MOORE SCHOOL OF ELECTRICAL ENGINEERING
UNIVERSITY OF PENNSYLVANIA

Constant Transmitter Gate Chassis C - Panel 2

Drawn by:	Checked by:	Approved by:	
C.J. McC Sept. 27, 1944	R.T. 10/4/44	21 Dec 44	PX-11-110

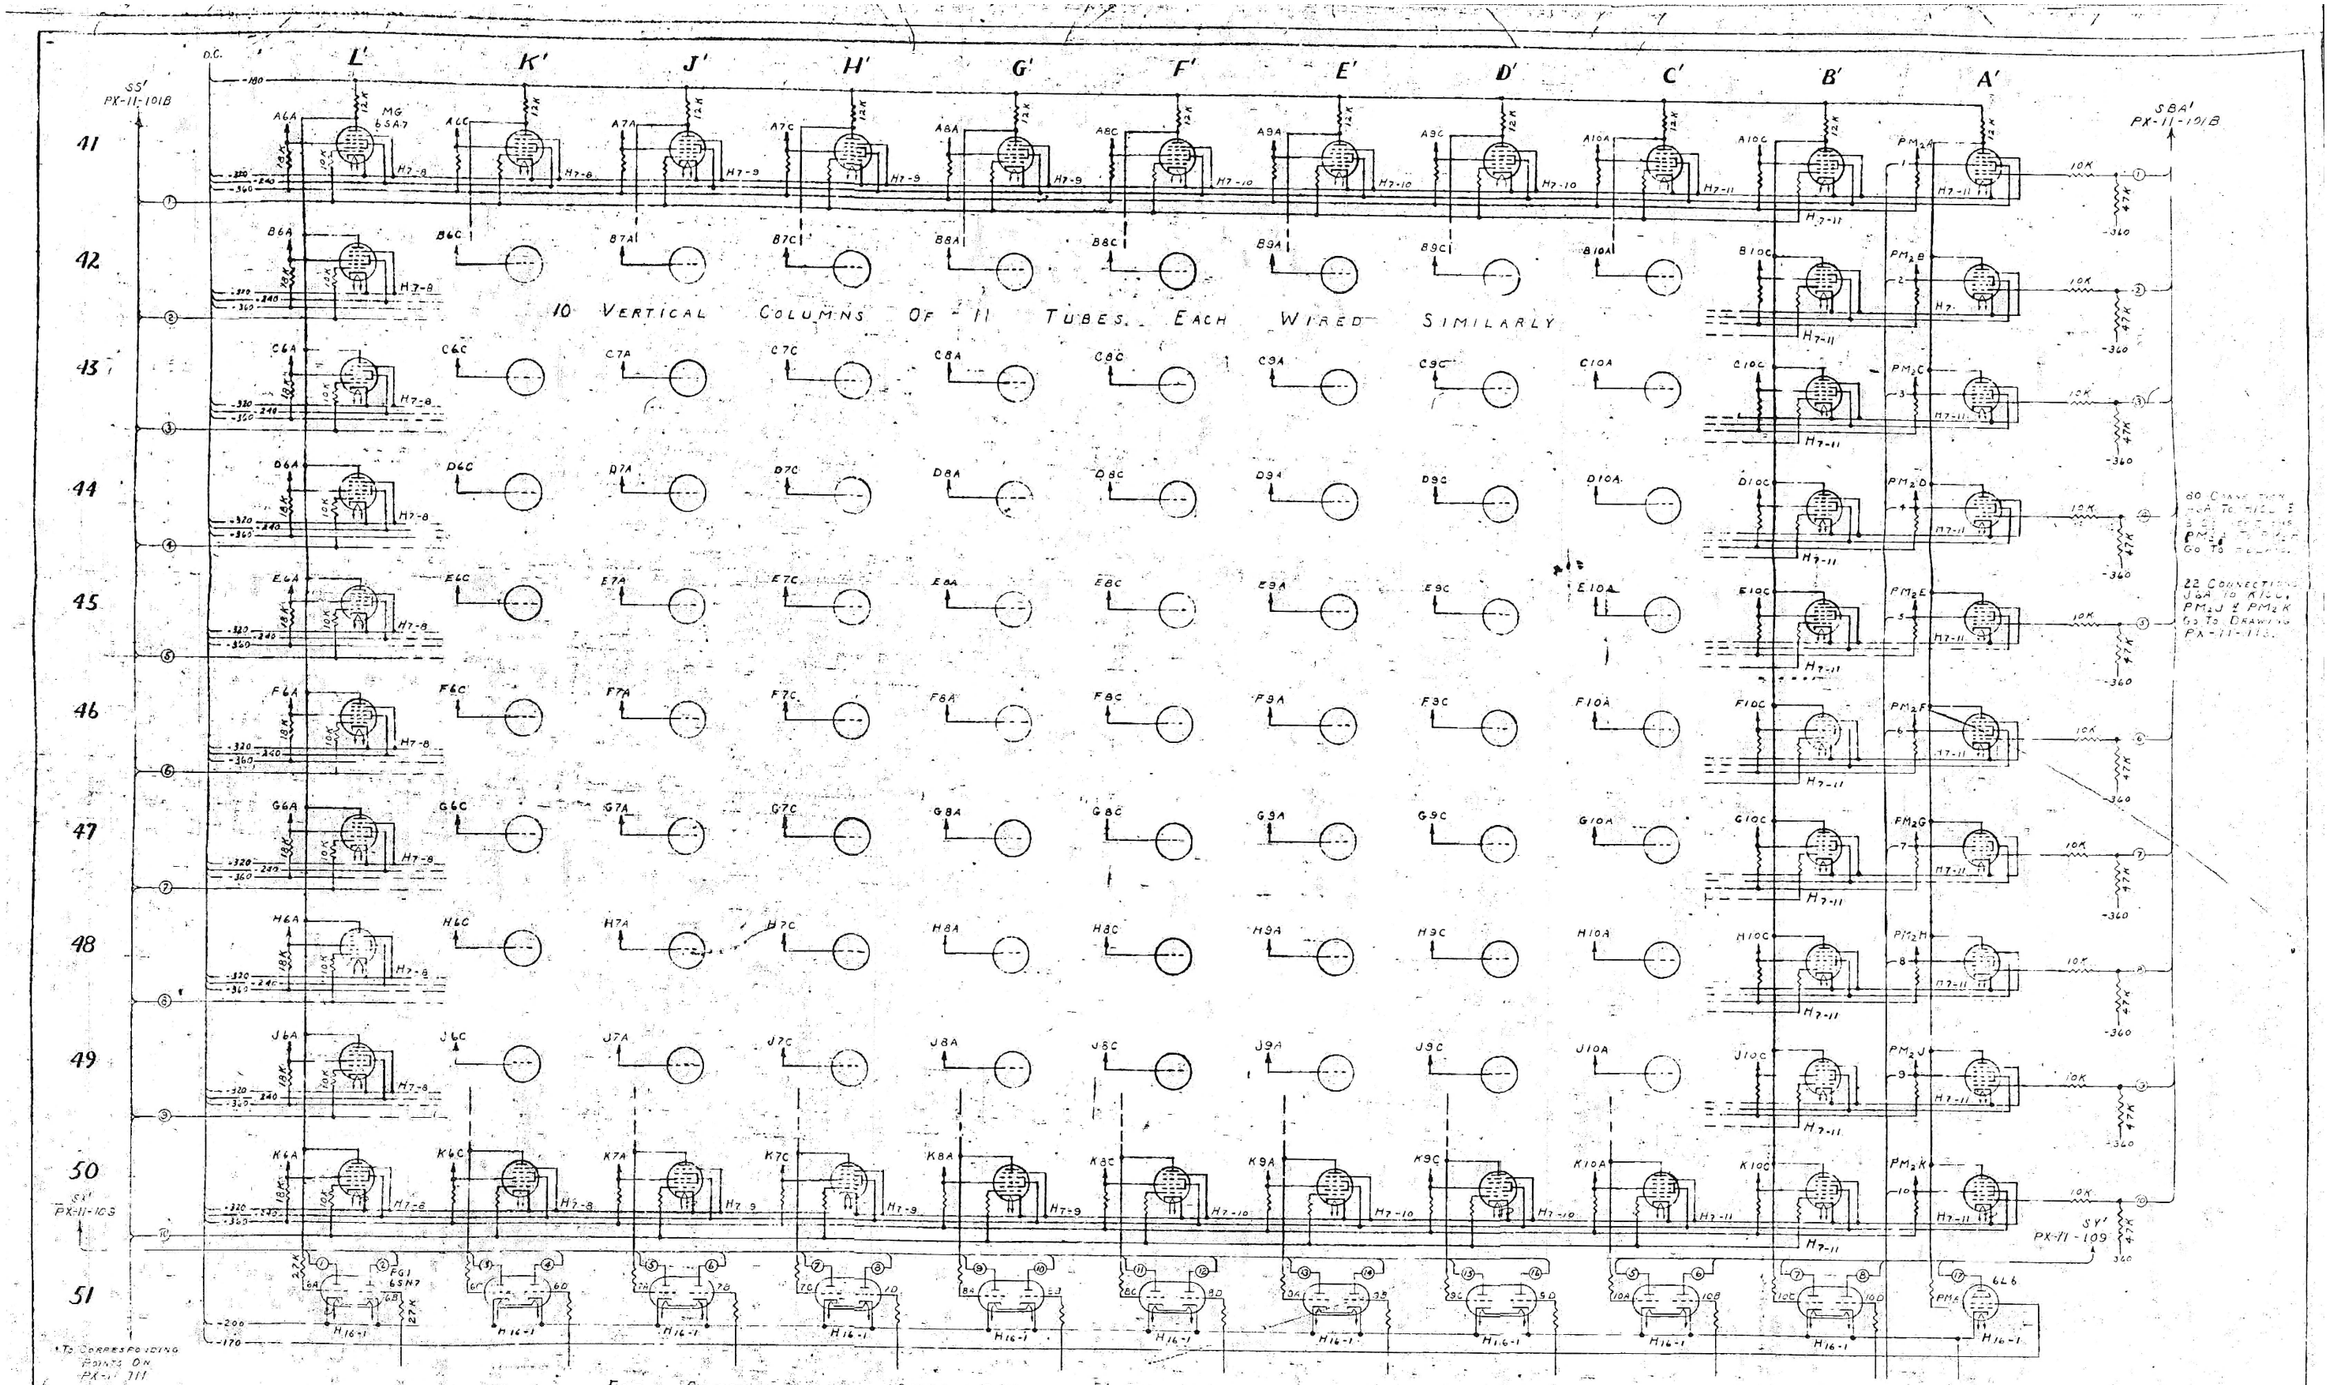
-375 Changed To -360. 2-70K Grid Resistors Changed To 10K. Connections Revised. Grid Leads Added.	R.T. Allen 2/14/44	1
Tube Numbering System Added.	R.T. Allen 5/5/44	2
Resistance Chart Added.	Wm. Chase 6/15/44	3
